### TOWN OF WELLINGTON PLANNING COMMISSION March 1, 2021 6:30 PM

Submitted By: Patty Lundy, Development Coordinator Subject: Meeting minutes of February 1, 2021

Subject: Conditional Use for Human Bean Drive Thru in the C1 Zoning District and Site Plan

SITE PLAN

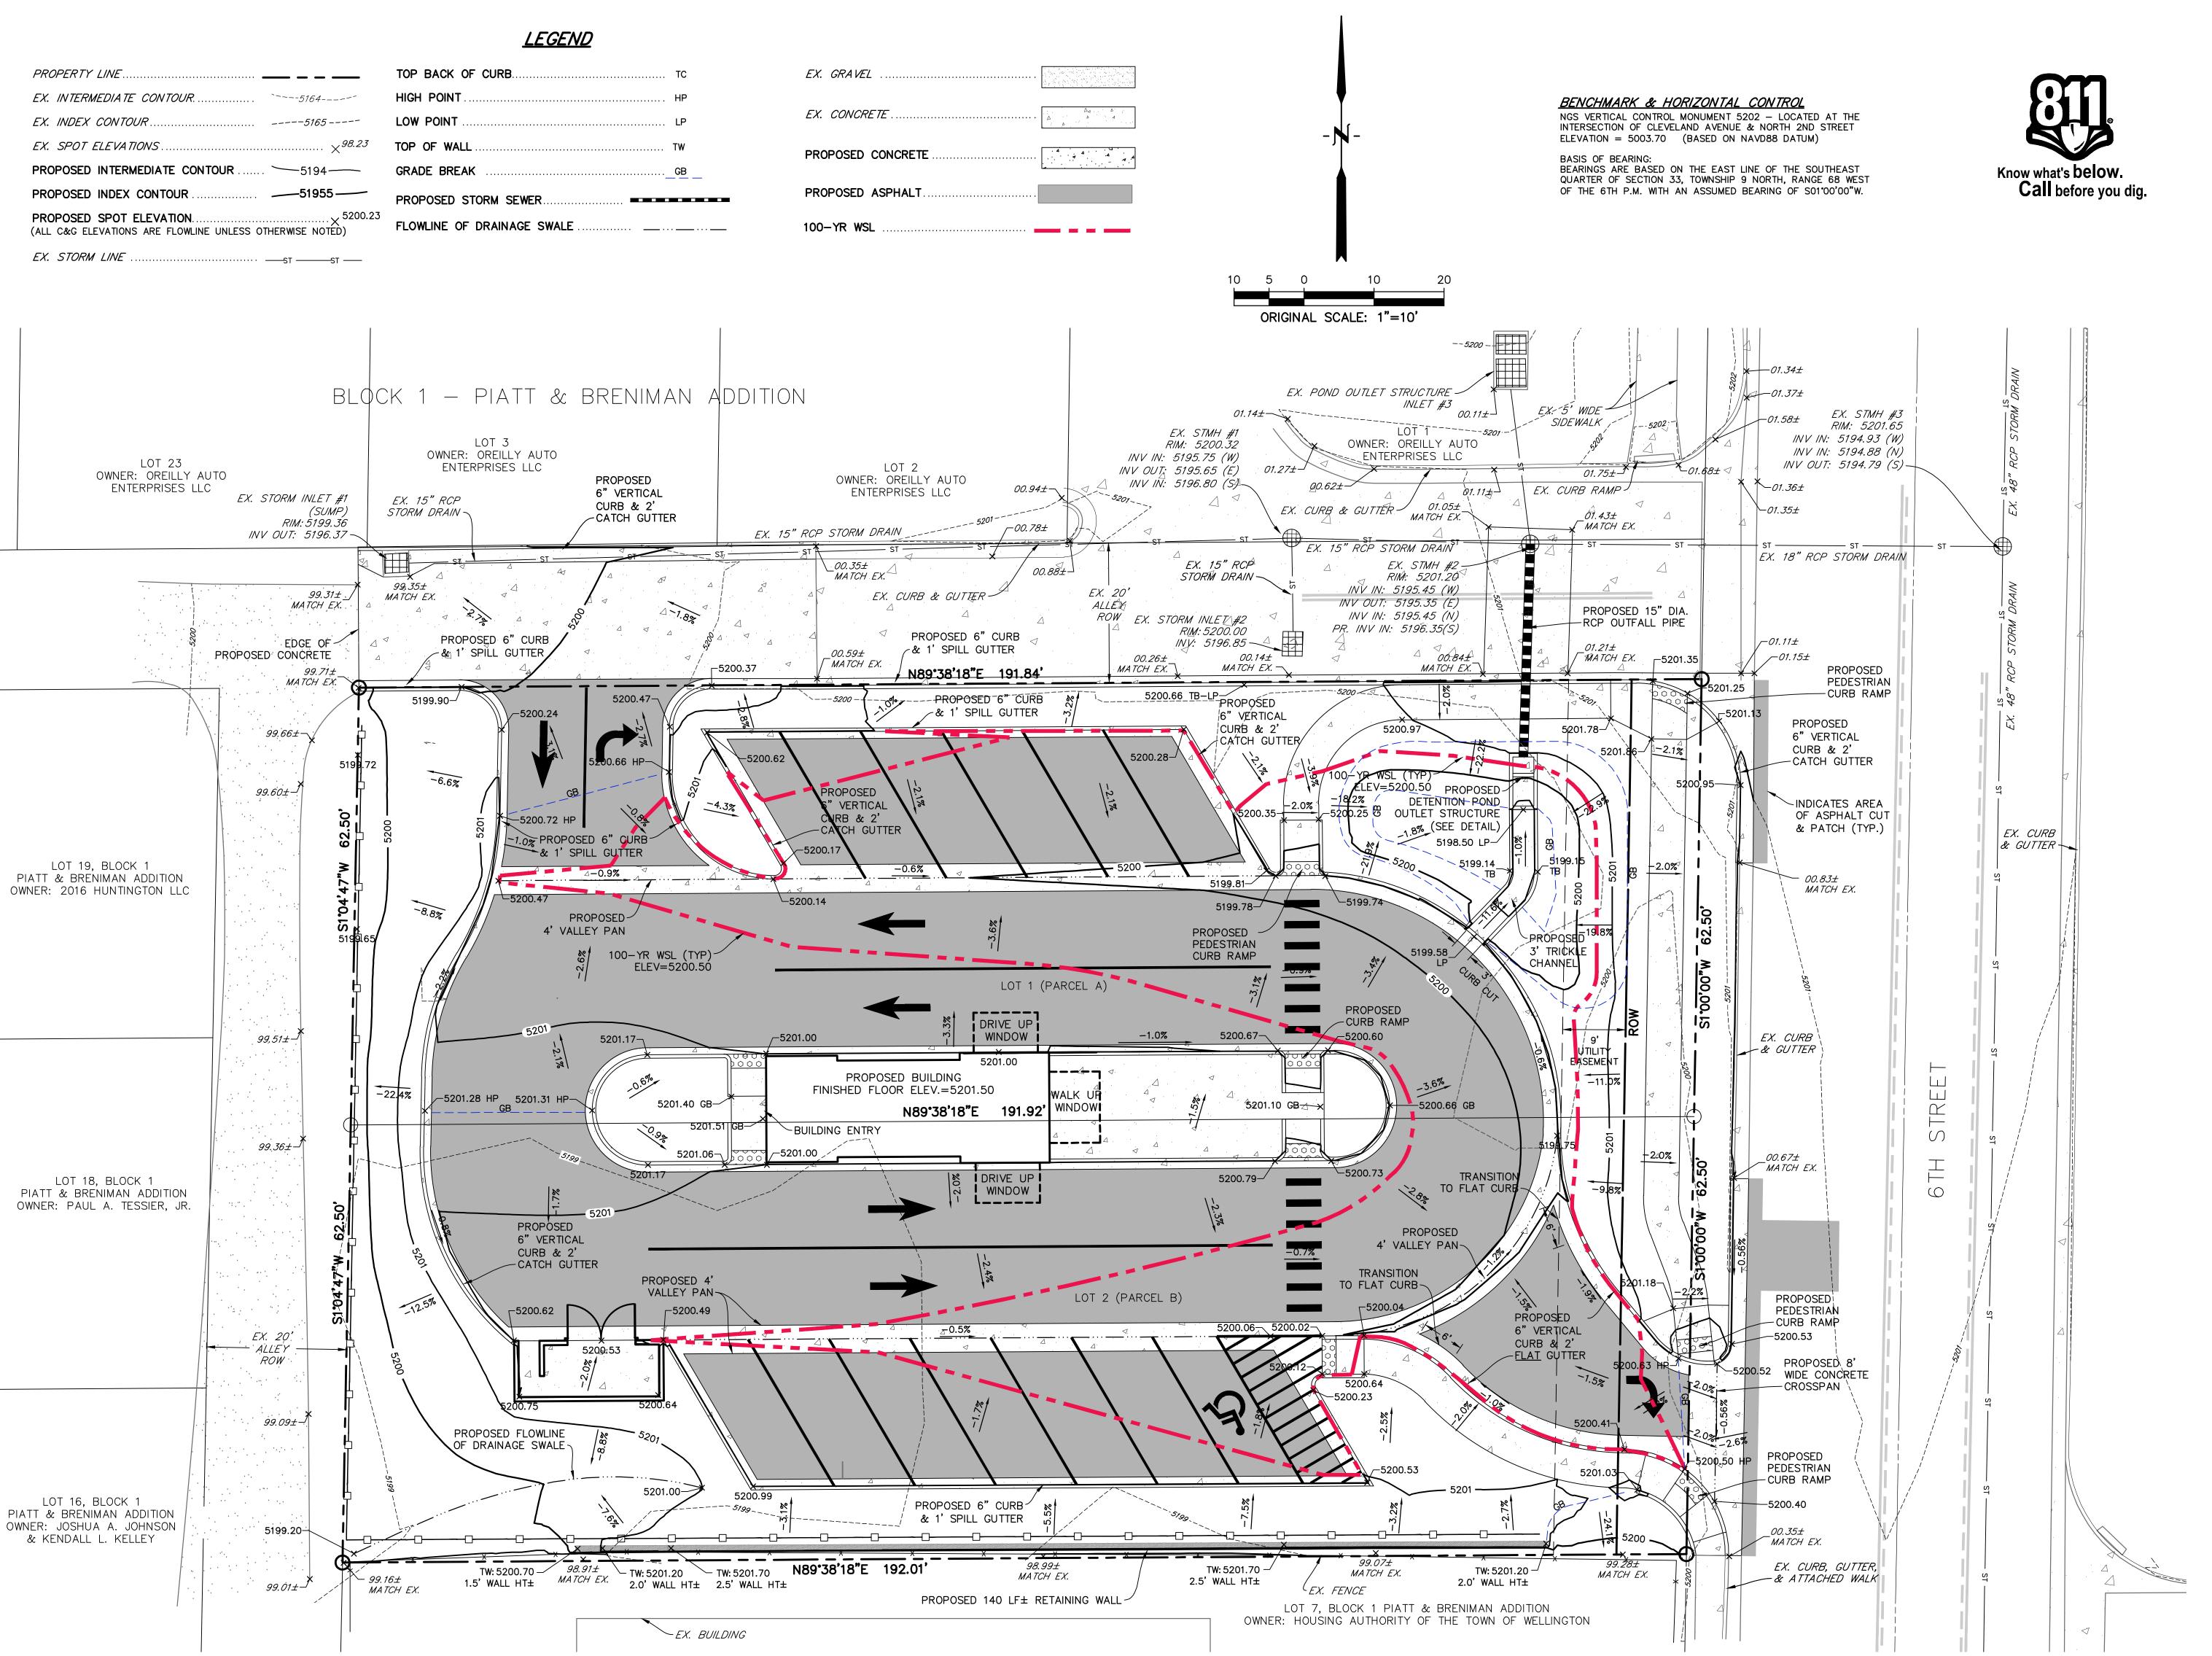
All existing and proposed dimensions have been noted on the attached sheet C1.0 Site Plan.
- 40' ROW required, with a 9' Utility easement.
  - An additional 10' ROW (for a 40' total ROW) and 9' utility easement have been included on the attached drawings and the site plan has been modified accordingly.
- Show dimensions for 5'-0" sidewalk.
  - Dimensions for 5'-0" sidewalk have been shown on the attached sheets C1.0 Site Plan and A0.1 Site Plan.
- Show dimensions of north alley.
  - Dimensions of north alley have been shown on the attached sheets C1.0 Site Plan and Sheet

- Extend concrete to property corner.
  - Concrete in north alley has been extended (along with curb and gutter) to the NW property corner as shown on the attached sheets C1.0 Site Plan and A0.1 Site Plan.
- Show site triangles at all accesses. Please coordinate with landscape designer and utilities.
  - Site triangles have been shown at all accesses and coordinated with landscape designer and utilities. See the attached sheets C1.0 Site Plan, C3.0 Utility Plan, and LS 1 Landscape Plan.

GRADING PLAN

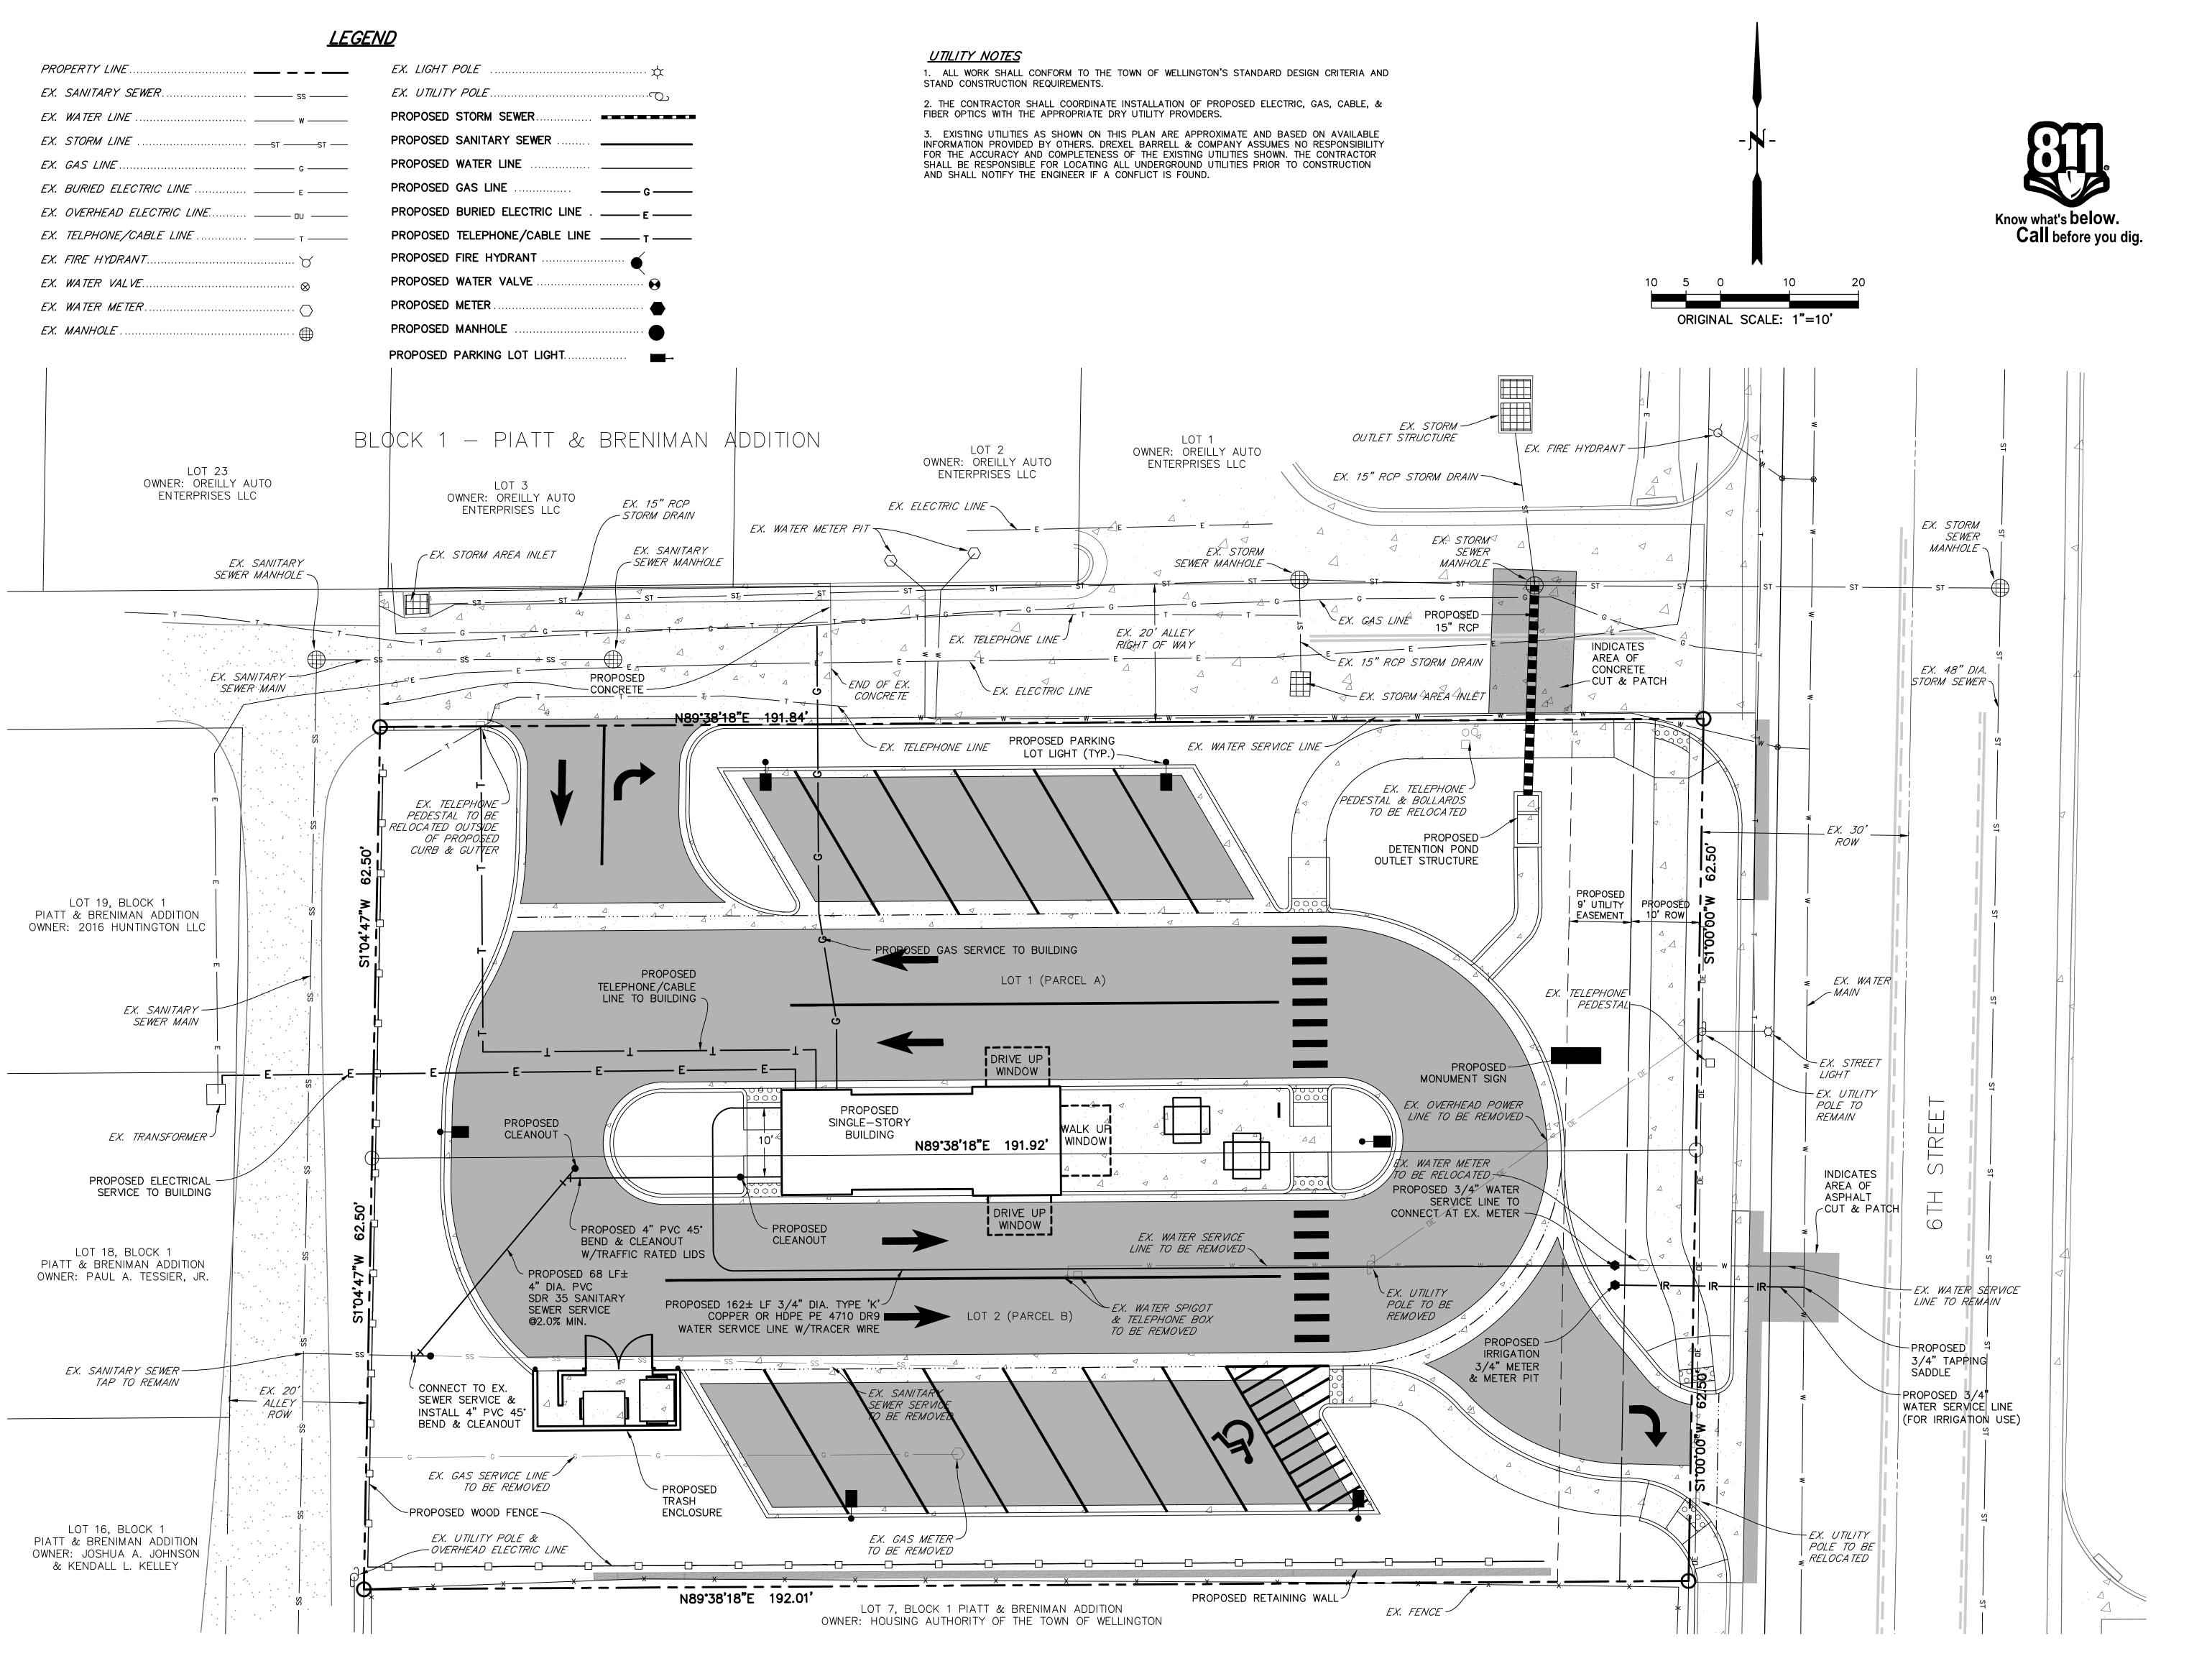
- Grade as needed to provide smooth transition.
  - The previous gravel area will now include concrete pavement and curb and gutter. The area is fairly flat and will simply match the existing surface at the west end such that no major grading transition is necessary. See attached sheet C2.0 Grading Plan.
- Address capacity and configuration of existing inlet. Change to Type R?
  - The existing area storm inlet does not have any capacity issues (refer to Drainage Report Calculations). The proposed curb and gutter can be constructed around the existing inlet since there is no need to convert the inlet to a Type 'R' inlet. See attached sheet C2.0 Grading Plan.
- Specify length of taper.

A retaining wall was necessary in order to capture and route drainage away from the south property. See attached sheet C2.0 - Grading Plan and Drainage Report.

Existing fence has been shown and labeled on the attached sheet C2.0 - Grading Plan.

Existing building has been shown and labeled on the attached sheet C2.0 - Grading Plan.
